SR 3/US 41/COBB PARKWAY WIDENING FROM PACES MILL ROAD TO AKERS MILL ROAD

STP00-0001-05(047), P.I. No. 721152

Value Engineering Study Report

March 2011

FILL WALL DETAIL

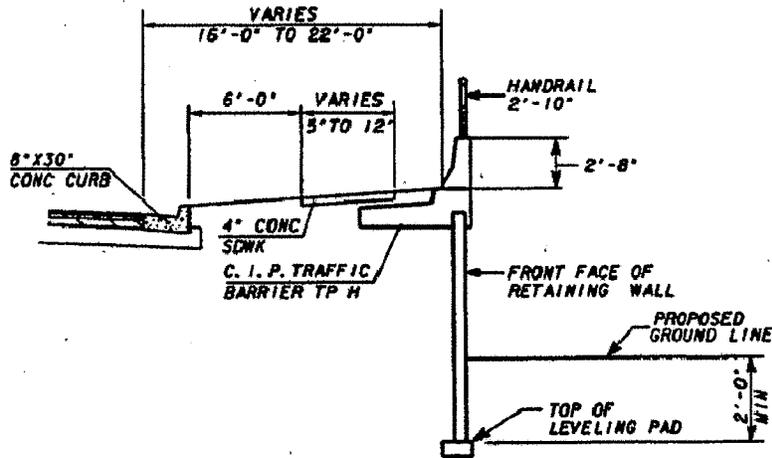
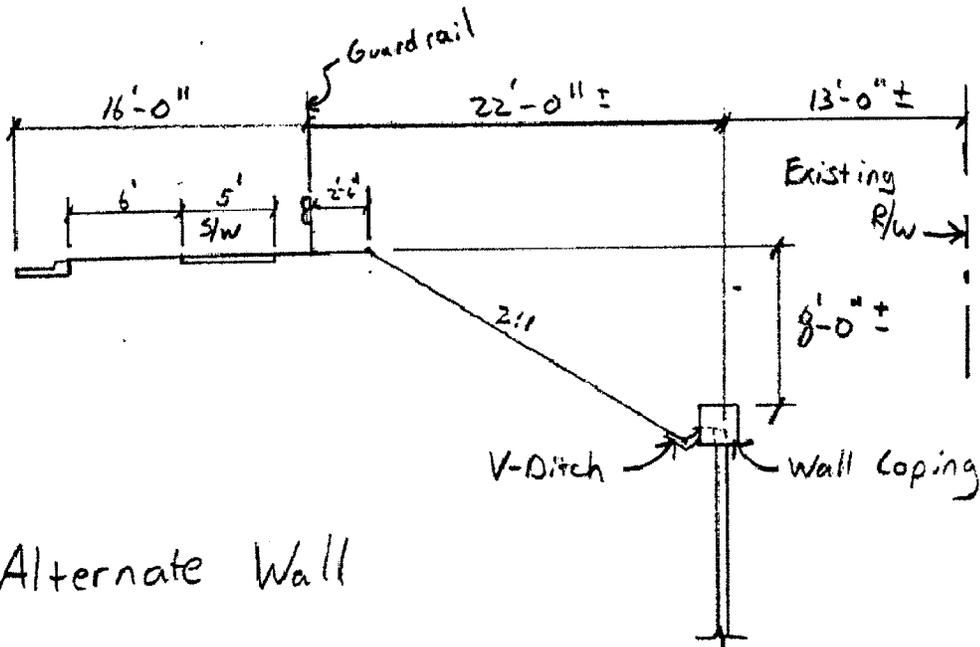
PROJECT: SR 3/US 41/COBB PKWY WIDENING FROM PACES MILL RD. TO AKERS MILL RD <i>Cobb County, Georgia</i>	ALTERNATIVE NO.: W-2
DESCRIPTION: REDUCE THE HEIGHT OF WALL NO. 2 BY SHIFTING THE WALL CLOSER TO THE EXISTING RIGHT-OF-WAY BOUNDARY AND GRADING THE SLOPE 2:1	SHEET NO.: 1 of 4

Shift the location of Wall No. 2 approximately 22 ft. closer to the existing right-of-way boundary and use a 2:1 slope with guardrail to reduce the wall height approximately 8 ft. Add 3 additional drainage structures and 550 ft. of 18 in. rigid concrete pipe to drain to structure B-6. Remove the traffic barrier and pipe handrail.

Alternate Wall

Original MSE Wall Elevation

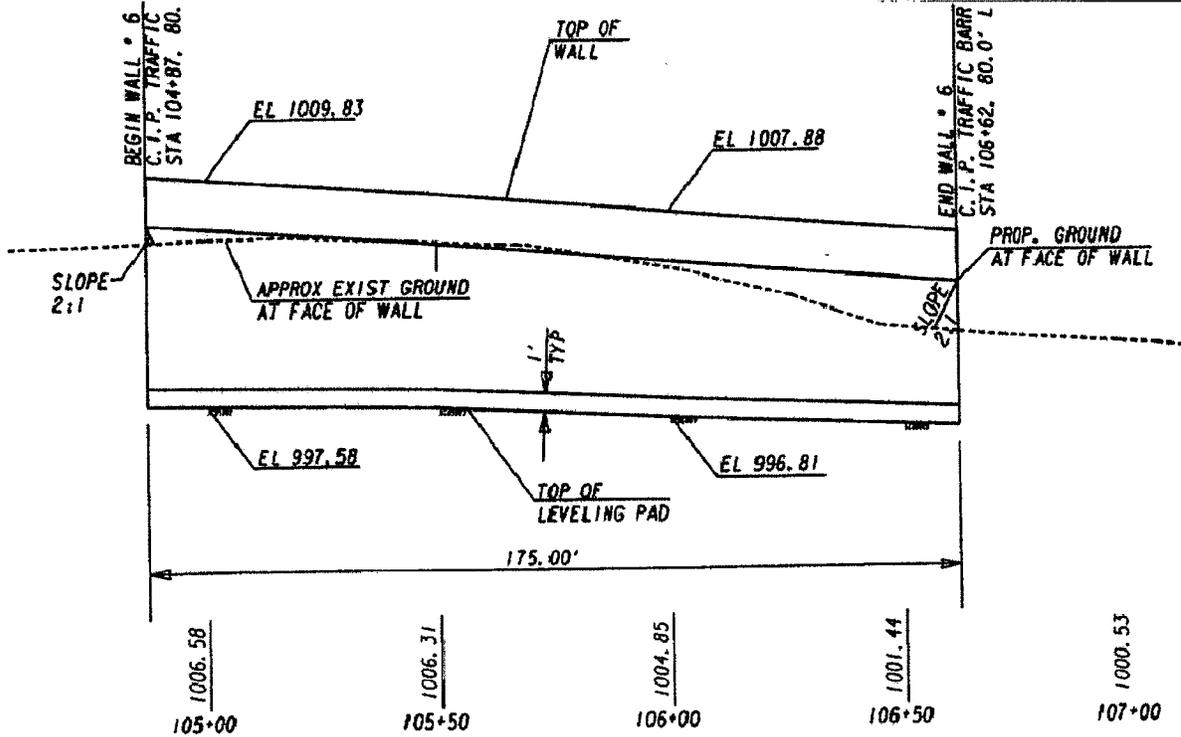
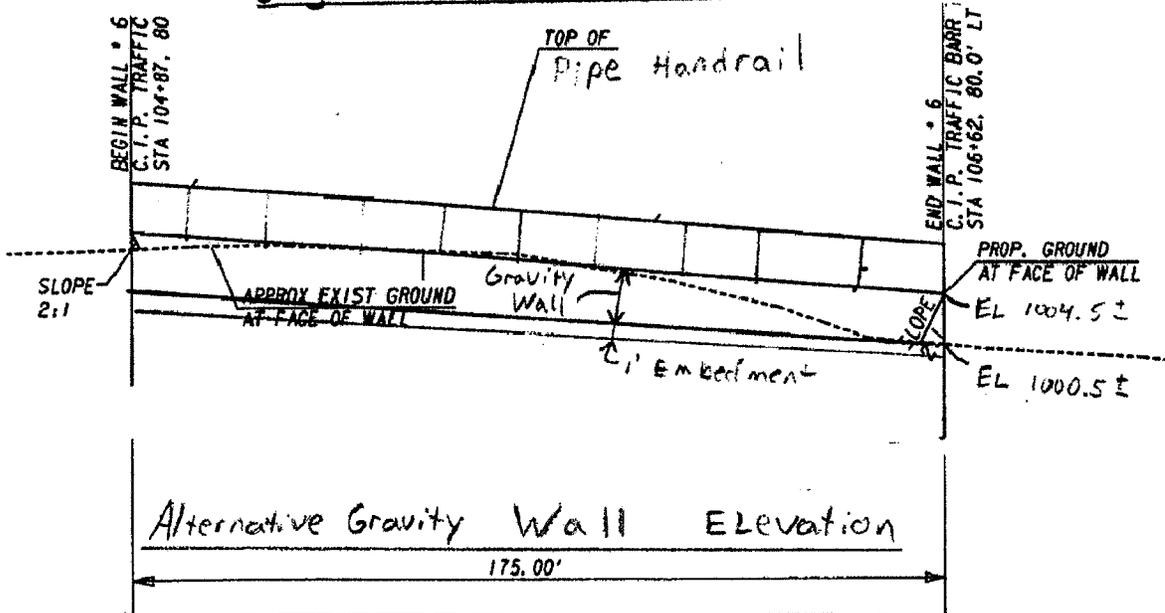
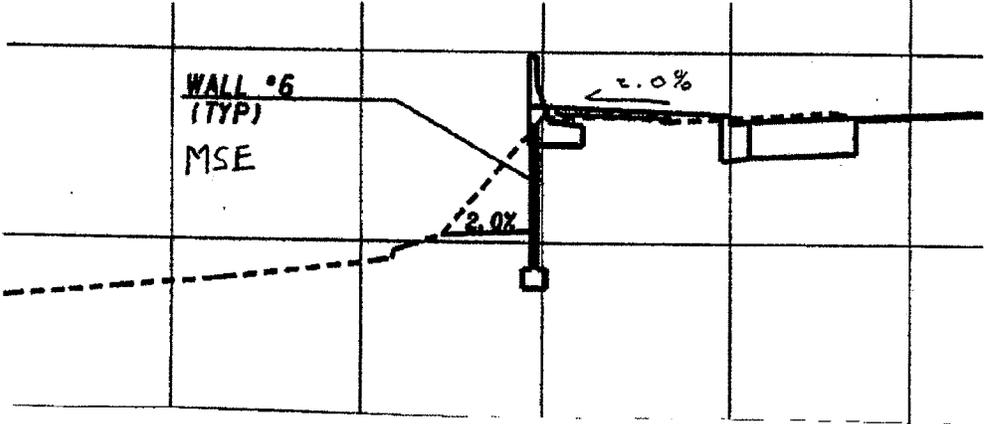
PROJECT: SR 3/US 41/COBB PKWY WIDENING FROM PACES MILL RD. TO AKERS MILL RD <i>Cobb County, Georgia</i>	ALTERNATIVE NO.: W-3
DESCRIPTION: USE A GRAVITY WALL WITH HANDRAIL IN LIEU OF A MECHANICALLY STABILIZED EARTH WALL FOR RETAINING WALL NO. 6 (STA. 104+87 LT TO STA. 106+62 LT)	SHEET NO.: 1 of 5

Use a gravity wall per GDOT Standard 9031L in place of an MSE wall for Wall No. 6. Add a 42 in. pipe handrail to the top of the gravity wall in lieu of the cast-in-place concrete traffic barrier.

The existing ground line is high in the area of Wall No. 6. Using a gravity wall reduces the average wall height requirement from 8.33 ft. to 4 ft. The earthwork requirements are also reduced. In addition, since Wall No. 6 is outside the clear zone, a traffic barrier is not required and can be replaced by a 42 in. handrail.

Alternative Gravity Wall Elevation

Original Design

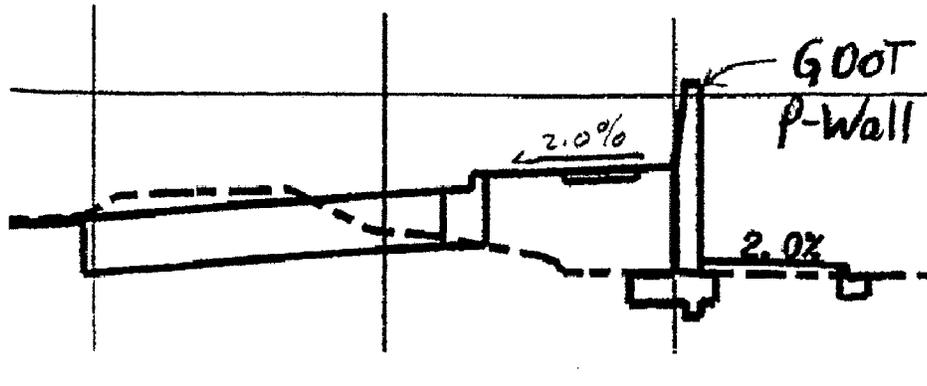
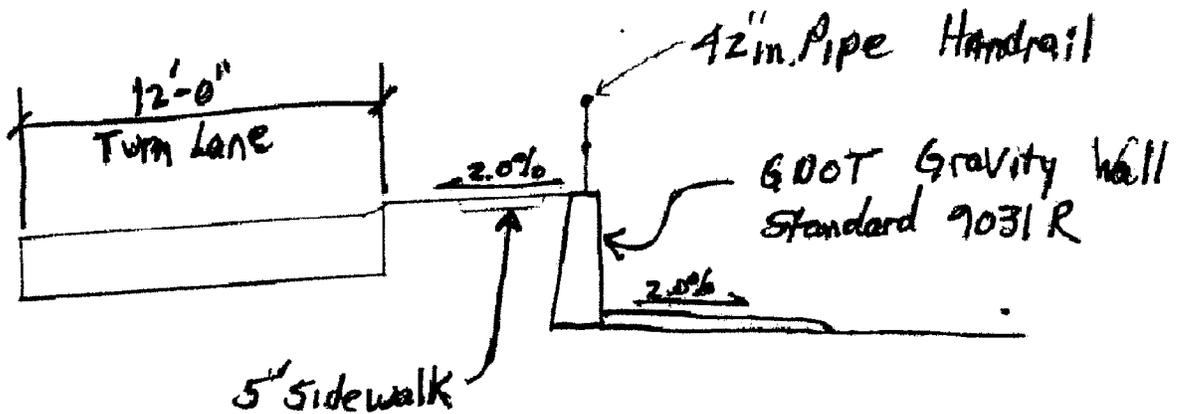
PROJECT: SR 3/US 41/COBB PKWY WIDENING FROM PACES MILL RD. TO AKERS MILL RD Cobb County, Georgia	ALTERNATIVE NO.: W-4
DESCRIPTION: USE A GRAVITY WALL WITH A HANDRAIL IN LIEU OF A PARAPET RETAINING WALL, TYPE P2 FOR WALL NO. 7	SHEET NO.: 1 of 4

Use a gravity wall in place of the GDOT P2 Wall. Add a 42 in. pipe handrail to the top of the gravity wall per GDOT Standard 9031R.

A 6 ft. high gravity wall can be used in this application to save material and labor requirements. The earthwork requirements are also reduced. Also, since Wall No. 7 is outside of the clear zone, a traffic barrier is not required.

Alternate Design

Alt. No. W-7
Sheet 2 of 4

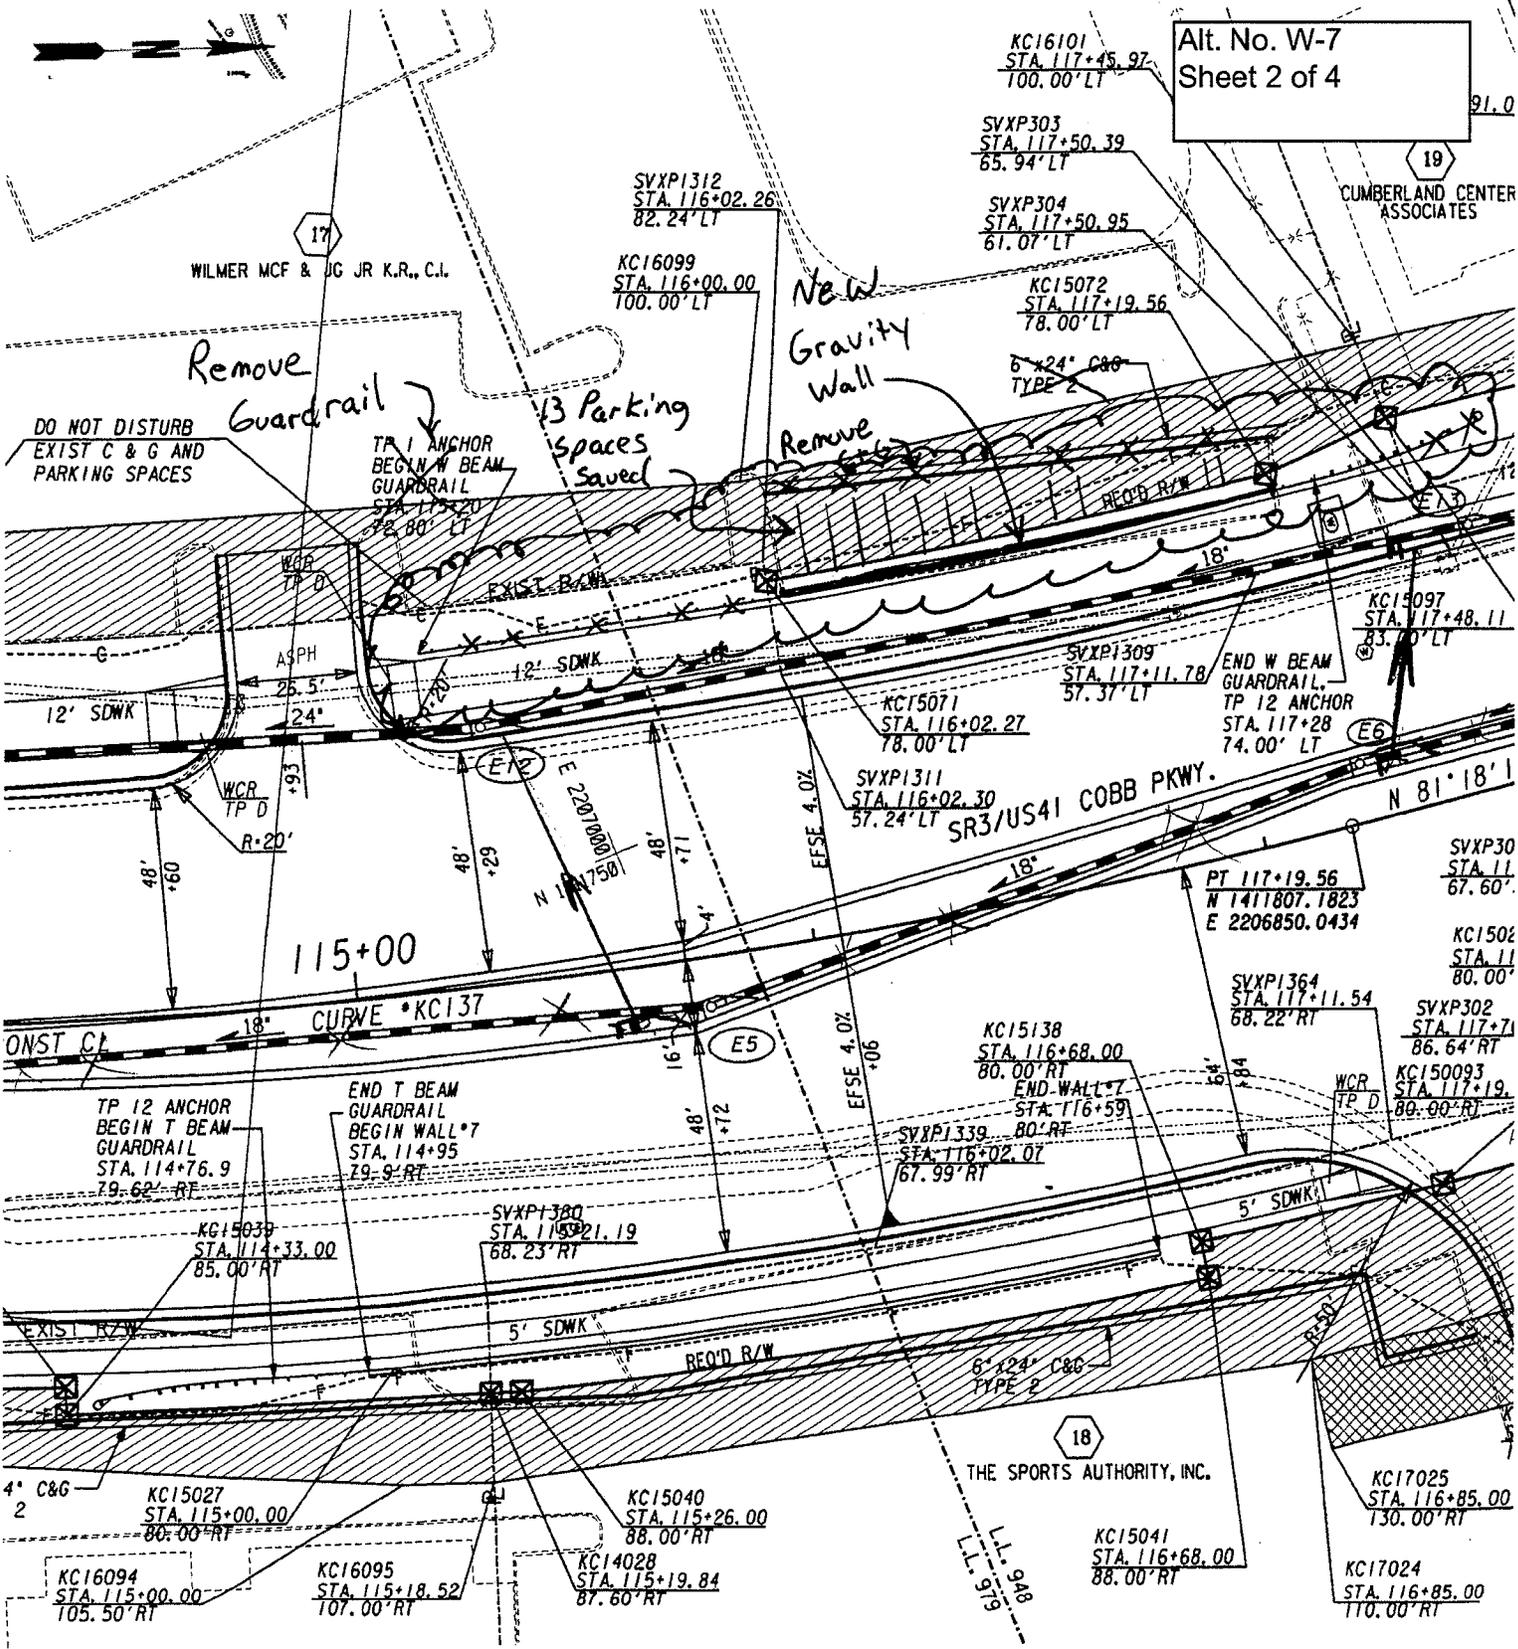
**DESCRIPTION: PROVIDE A GRAVITY WALL FROM STA. 116+00 TO STA.
117+00 TO SAVE PARKING SPACES**

The original section uses small 2:1 slopes and curb and gutter with guardrail that eliminates 13 parking spaces. The location of the guardrail is outside the clear zone, therefore in order to save parking spaces, use a gravity wall to remove the 2:1 slope. A 42 in. pipe handrail has been added on the gravity wall for pedestrian and bicyclist safety.

Original Wall Detail w/Traffic Barrier

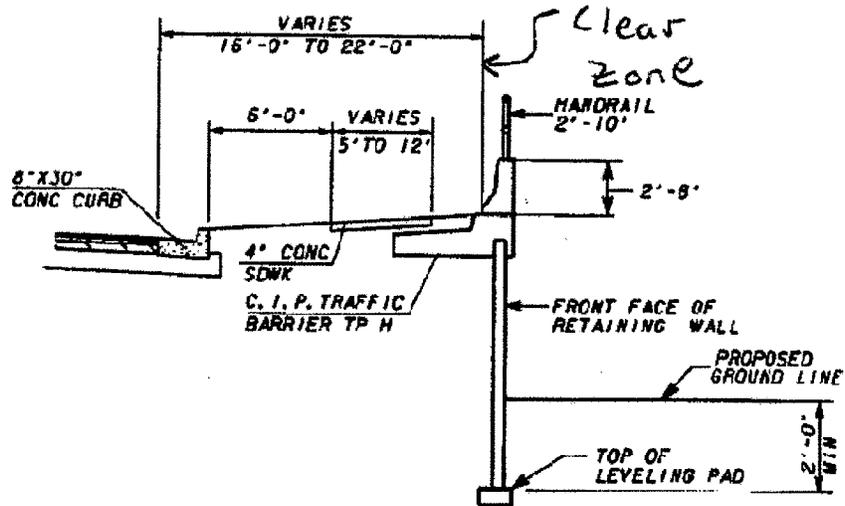
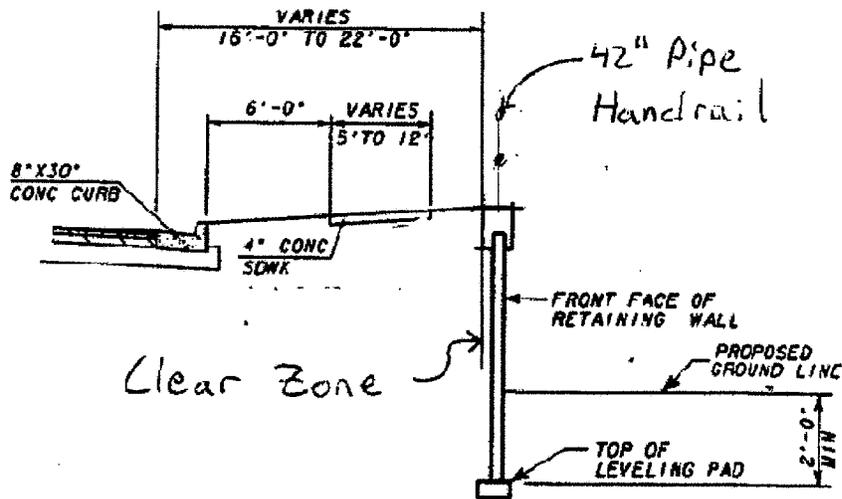
**DESCRIPTION: REMOVE THE TYPE H TRAFFIC BARRIER AND PROVIDE
A 42 IN. PIPE HANDRAIL ON TOP OF WALL NOS. 1, 3,
AND 6**

Outside the clear zone remove the Type H Traffic Barrier. Add a wall coping with a 42 in. pipe handrail on the wall coping on top of Wall Nos. 1, 3, and 6.

Alternative Wall Detail with 42 in. Pipe Handrail

ALT. NO.
D-1
SMT. 2 of 5

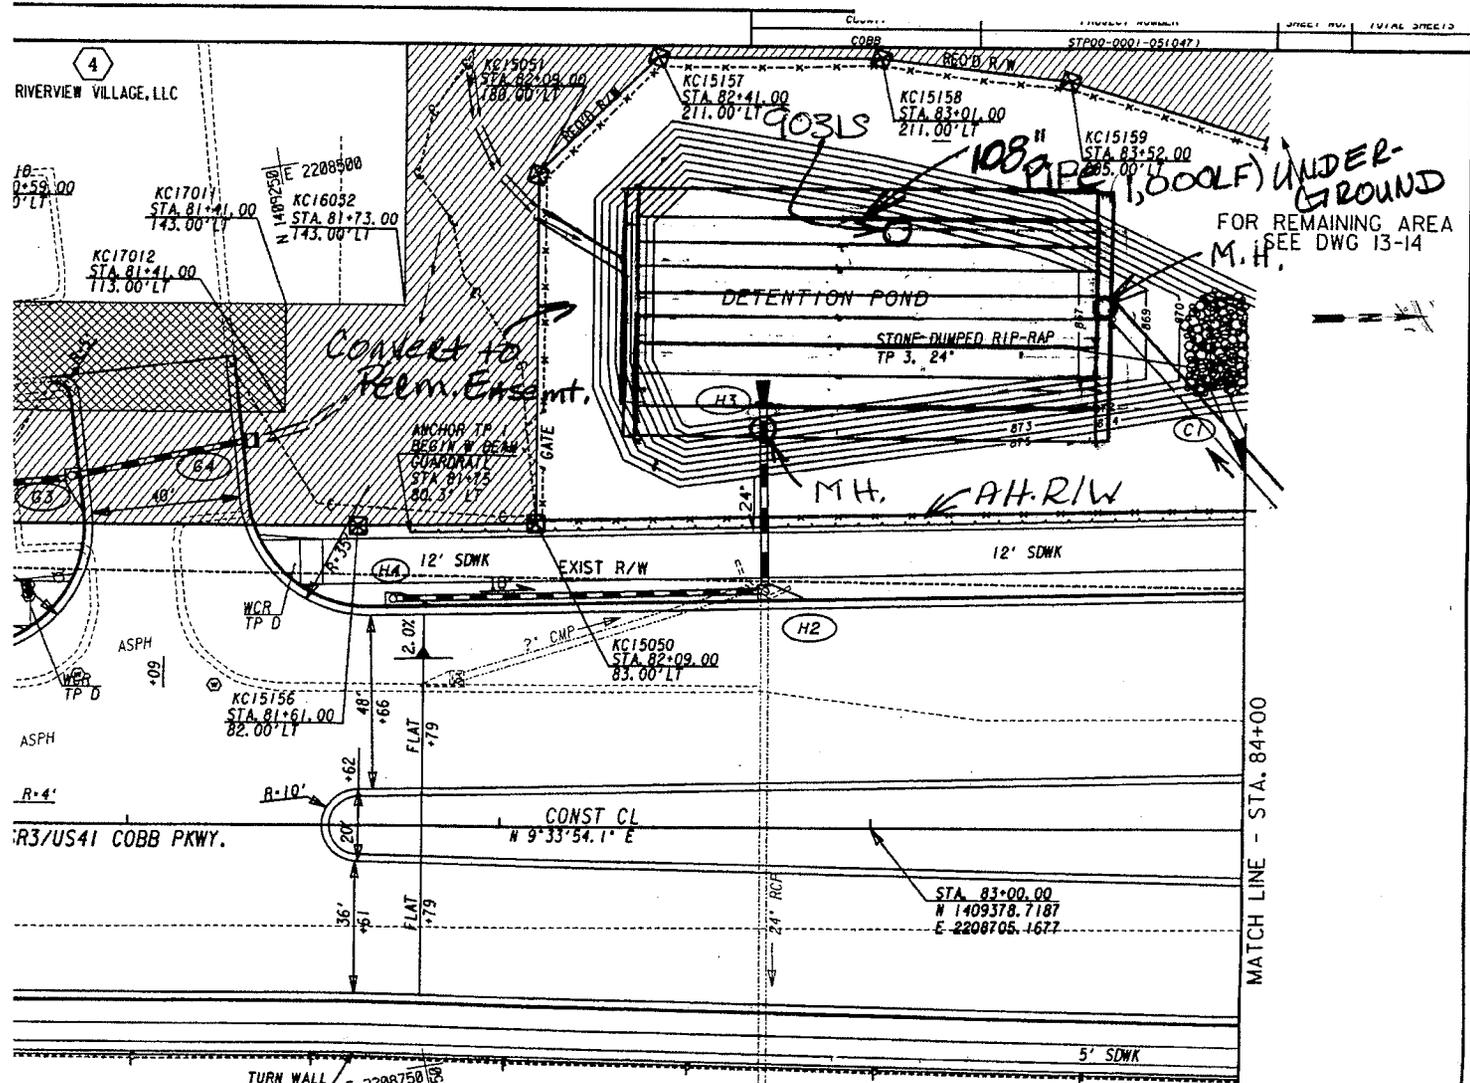
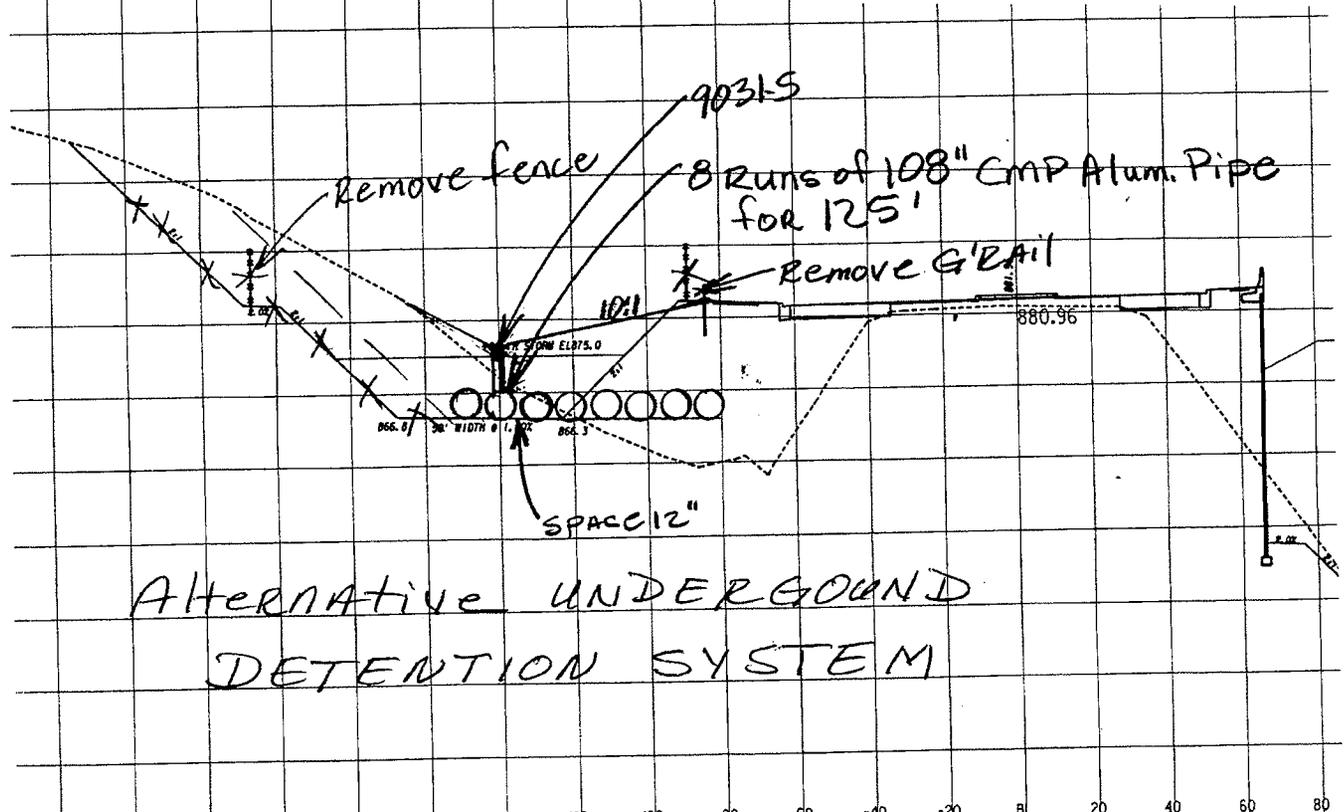
**DESCRIPTION: PROVIDE UNDERGROUND DETENTION IN LIEU OF AN
ABOVE GROUND DETENTION BASIN AT STA. 83+00 LT**

Provide an underground detention system in lieu of the above ground sediment detention basin.

The current detention design damages a large portion of Parcel 4 for commercial development because it requires approximately 0.60 acres of additional right-of-way and 16,000 SF of construction and maintenance easement. The underground detention will allow certain types of commercial development such as parking. The underground system would eliminate the need for maintenance of the above ground sediment basin.

ALTERNATIVE UNDERGROUND
DETENTION SYSTEM
